DOUBLE BRIDGES ROAD PATHWAY, MUDDY NECK TO NEPTUNE DRIVE

CONTRACT NUMBER: T201769009
FEDERAL AID PROJECT NUMBER: CMAQ-2020(38)
COUNTY: SUSSEX M.R. #: S363

ADDENDUM 2
October 1, 2026

THIS SEAL APPLIES TO THE FOLLOWING SHEETS
CHANGED UNDER ADDENDUM #2:
1, 3, 23, 24, 28, 29, 31, 60

PEDESTRIAN BRIDGE CLEARING & GRUBBING LIMITS DETAIL
STA. 2098+00.00 TO STA. 2100+00.00

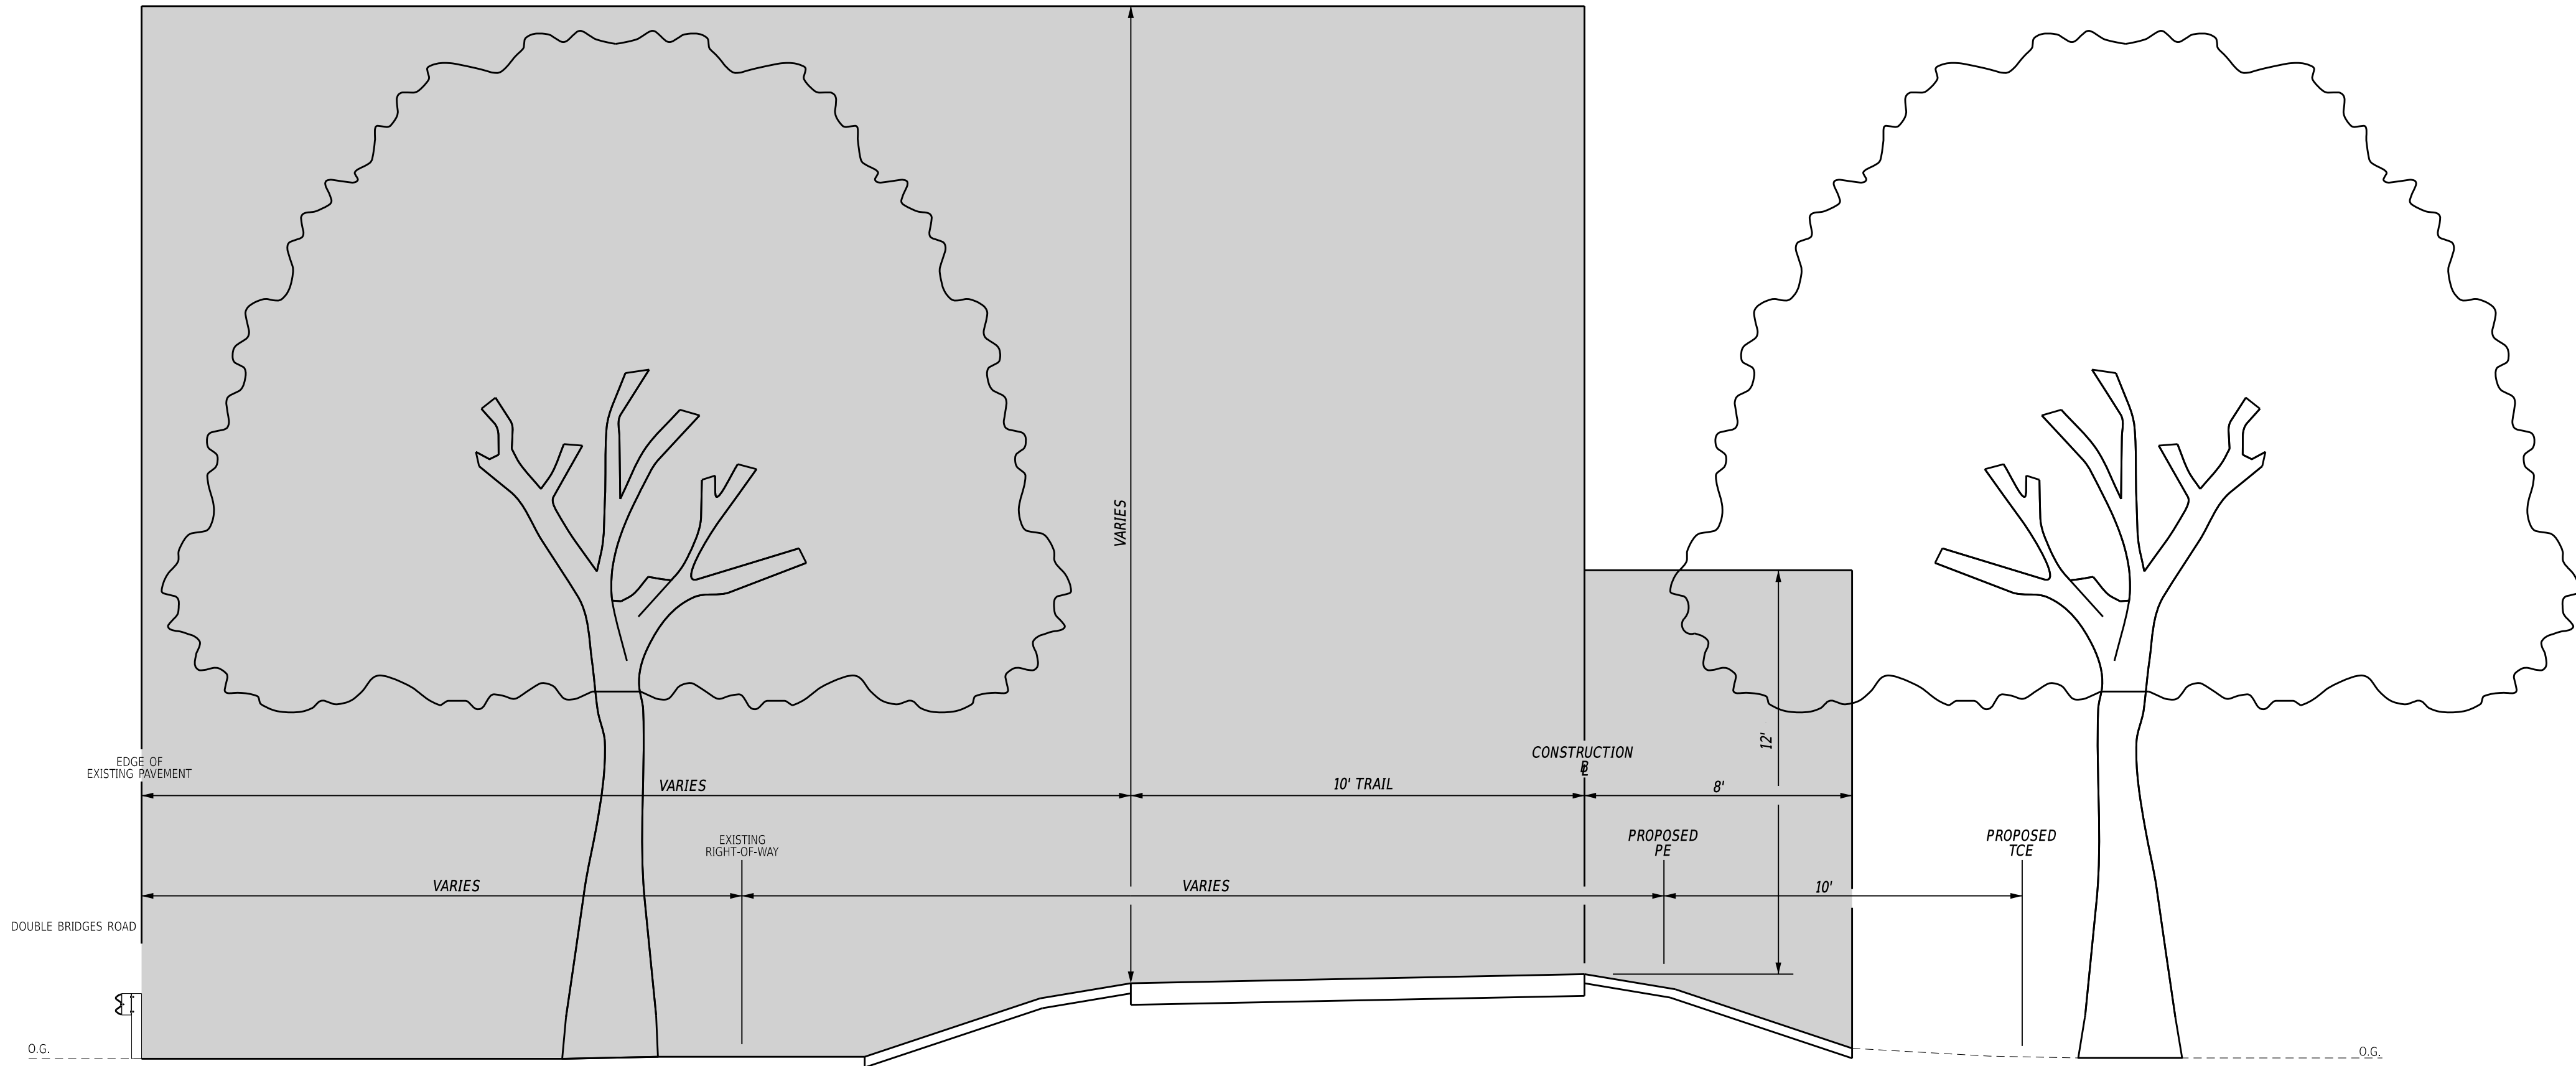
Addendum No. 2: Details added. Changed Item # for Drainage Inlet, Special. TMB 9/28/26

ABUTMENT PLAN,
ELEVATION & SECTION

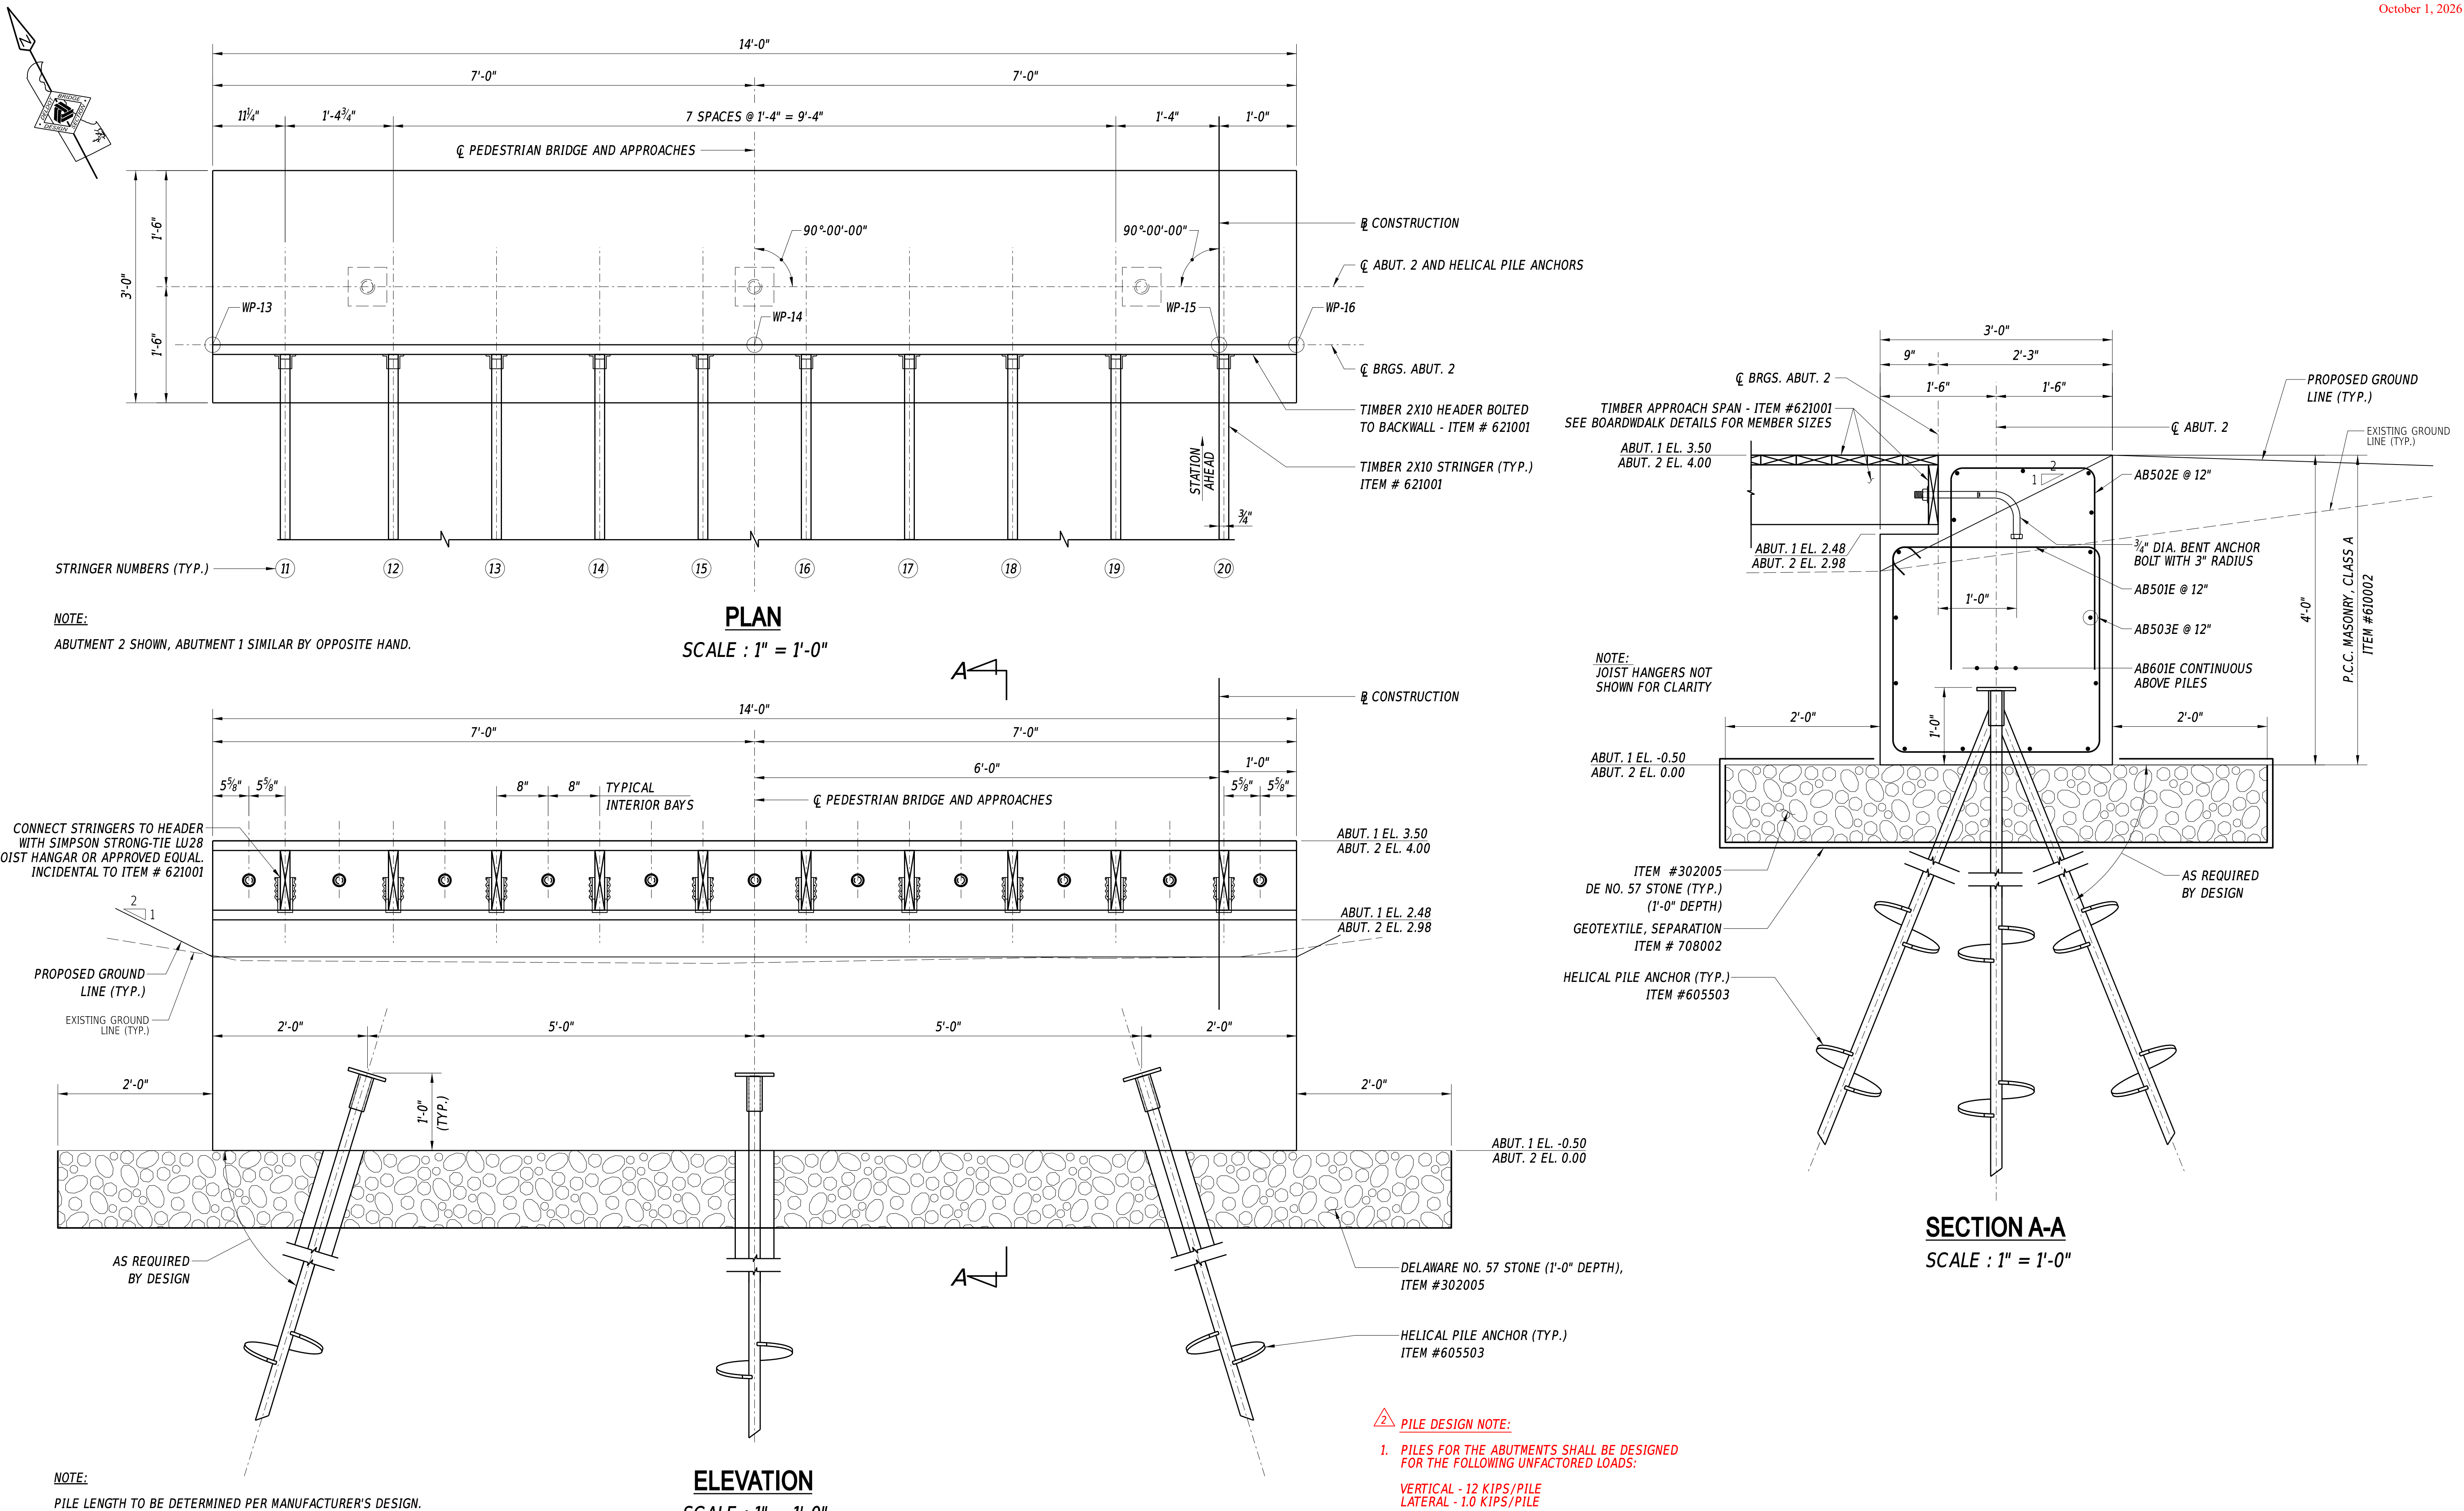
△ ADDED PILE LOADING. BMC 9/28/26
